Notice of a Meeting
Dalworthington Gardens Planning and Zoning Commission

April 3, 2025 at 6:00 p.m.

3. Approval of Minutes
 - i. 2.6.2025 Minutes
4. Discussion and possible recommendation on an application for a preliminary plat submitted by Aldridge Building Corp for Lot 19, Block A, 1.001 acres of land located in The Joseph Pierce Survey, Abstract No. 1253 an addition to the City of Dalworthington Gardens, Tarrant County, Texas, and locally known as 3815 Kelly Perkins Road.

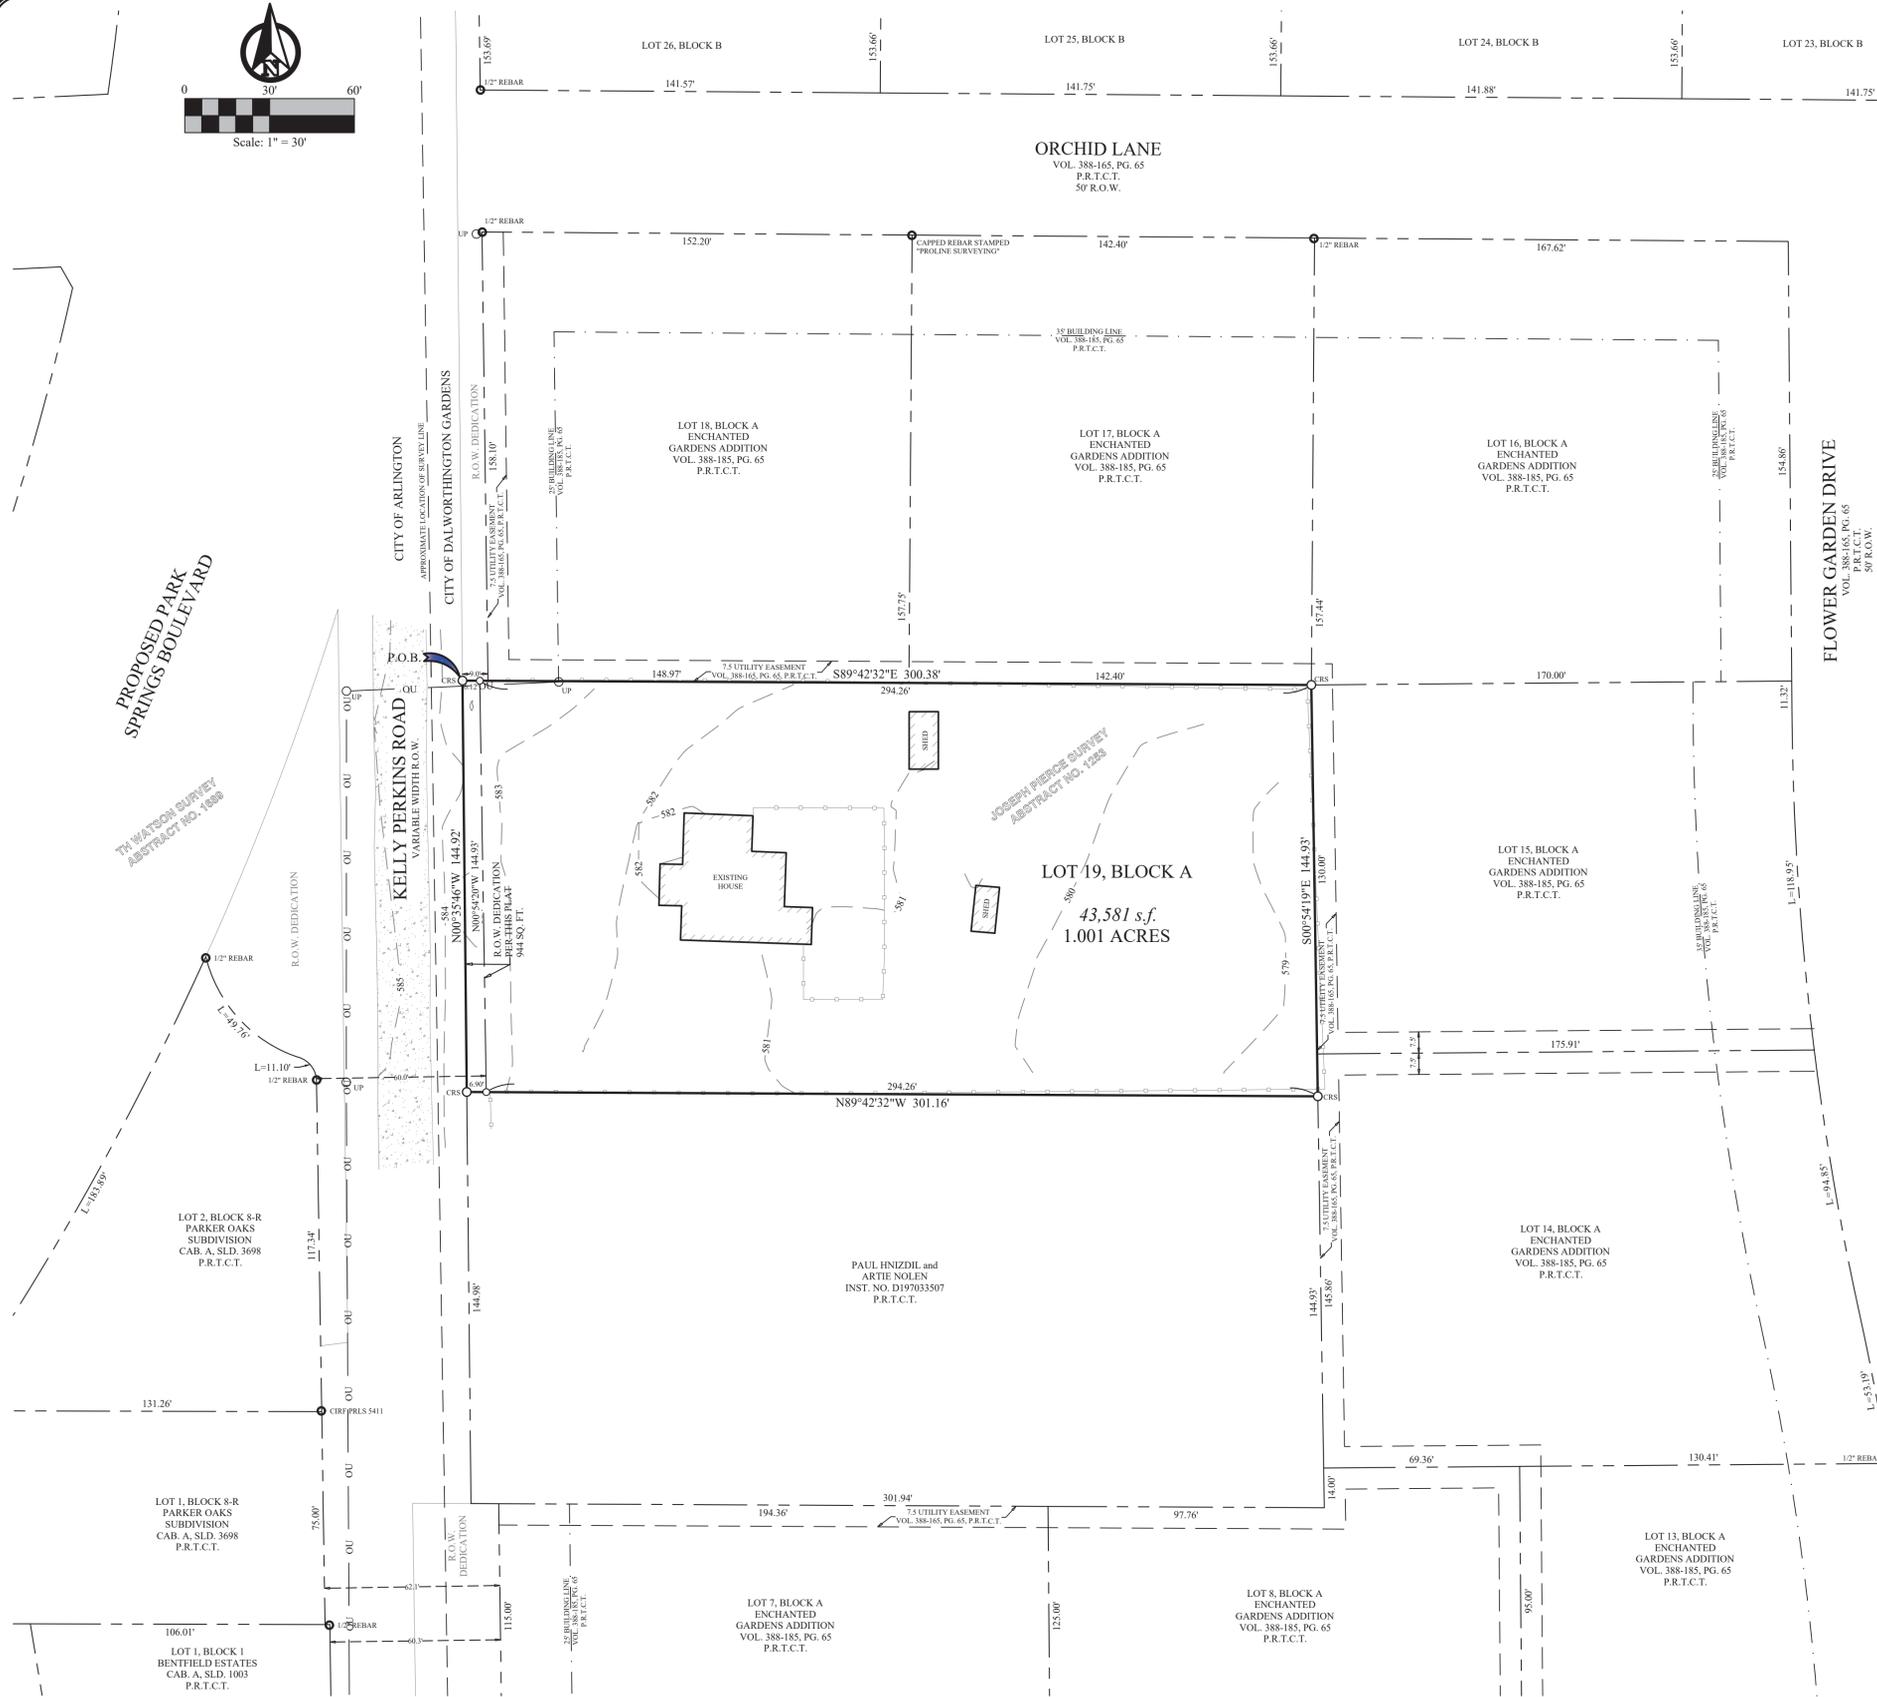
- 1) Provide the names of all adjacent property owners and match descriptions with the Appraisal District records.
- 2) Show and label all building setbacks per section 14.02.171 or the Code of Ordinances.

- 3) Show and label all existing utilities on and adjacent to the property and label the line sizes.
- 4) Note benchmarks used.
- 5) Any major proposed changes in topography shall be shown by labeled contour lines.

- 6) Provide a preliminary water and sewer exhibit that shows how water and sewer service will be provided to the lot.
- 7) Label the lot acreage minus the ROW dedication.

- 8) Provide a preliminary drainage plan to show how the property will drain.
- 9) Label the right of way width for all roadways.
- 10) Include the certifications and statements listed in section 10.02.123/2 and verify that they match the ordinance exactly. These certifications and statements can be found as attachments to Chapter 10 of the online Code of Ordinances.
